Appendix A

**Comments of the Columbia River Inter-Tribal Fish Commission
Regarding the NOAA Fisheries' September 8, 2004 Draft Biological Opinion
For Operation of the Federal Columbia River Power System
October 8, 2004**

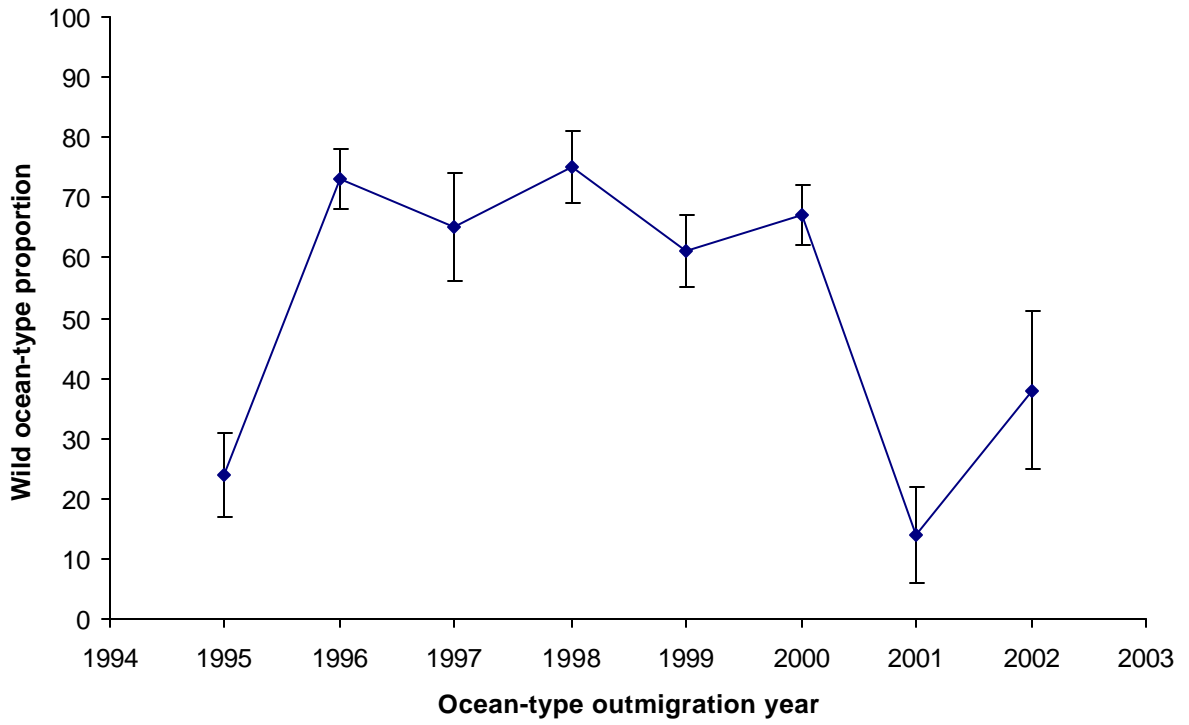
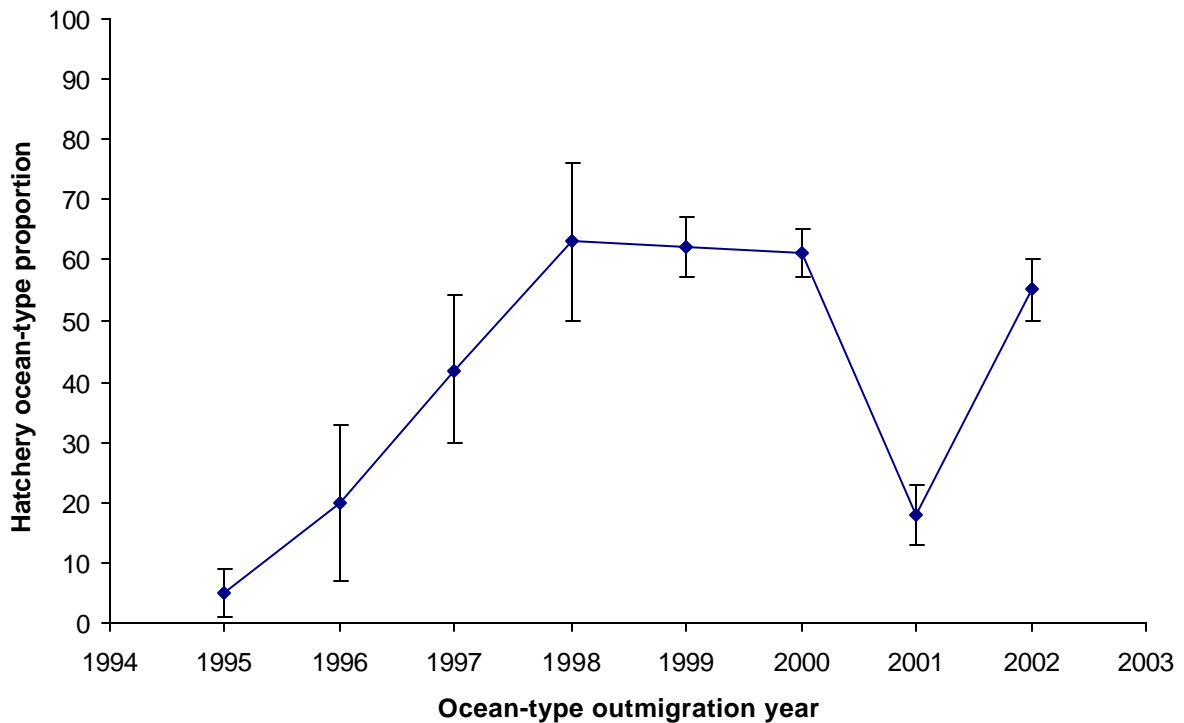
The effects of the action on – and related operation of the system for – fall Chinook are based on a faulty analysis. The BiOp references a new publication (Connor et al., 2004 *in print*) that discusses life histories for fall Chinook. Draft BiOp at 6-50. The paper and the BiOp identify an ocean-type fall Chinook life history that would represent what is currently referred to as the fall Chinook sub-yearling. The paper then goes on to discuss what it calls a reservoir style fall Chinook. This is one where instead of migrating in the late summer and early fall, the fall Chinook remain in the river system and complete their ocean migration the following spring. While we do not contest that this does occur, we are concerned with implication that a large majority of the migrants display this behavior. Referring to the charts below it is apparent that percentage of reservoir fall Chinook is highly variable for both wild and hatchery Chinook. What is more interesting to note is that reservoir migrants represent a large majority of the run when in river conditions are poor. Therefore the ocean-type proportions may simply function as an index of flow and inriver survival conditions for the ocean-type migrants. Further, flow and survival conditions in the following year (for the yearling component) may also be influencing these proportions. Both 1995 and 2001 provided sub-optimum conditions for in-river migration. The increase in reservoir Chinook migrants could be an indication that in river conditions were so poor that the ocean migrants suffered catastrophic mortality and

by default the only adults returning were the ones that did not migrate during the poor river conditions.

Furthermore, reviewing a paper by the same author, Connor et al. August 2002 in the North American Journal of Fisheries Management, the paper concludes that the majority of the reservoir type Chinook appears to originate in the Clearwater. The Upper Snake reach accounted for no more than a couple of percentage while the Lower Snake had more variation with an average of nearly 9% for the years of 1994 to 1999. A high 18.5 occurred in 1996 which was a cooler and higher flow year than normal. The Clearwater averaged 52.7% for the years 1992 – 1994. As the paper indicates this is related to river temperatures and this matches with current reservoir operations at Dworshak that aid in making this reservoir type life history possible. Therefore this life history only is really possible in the areas where cool temperatures occur during the rearing stage of the fall Chinook. If it was not for the creation of the reservoirs from the construction of the hydro electric projects this life history would not exist.
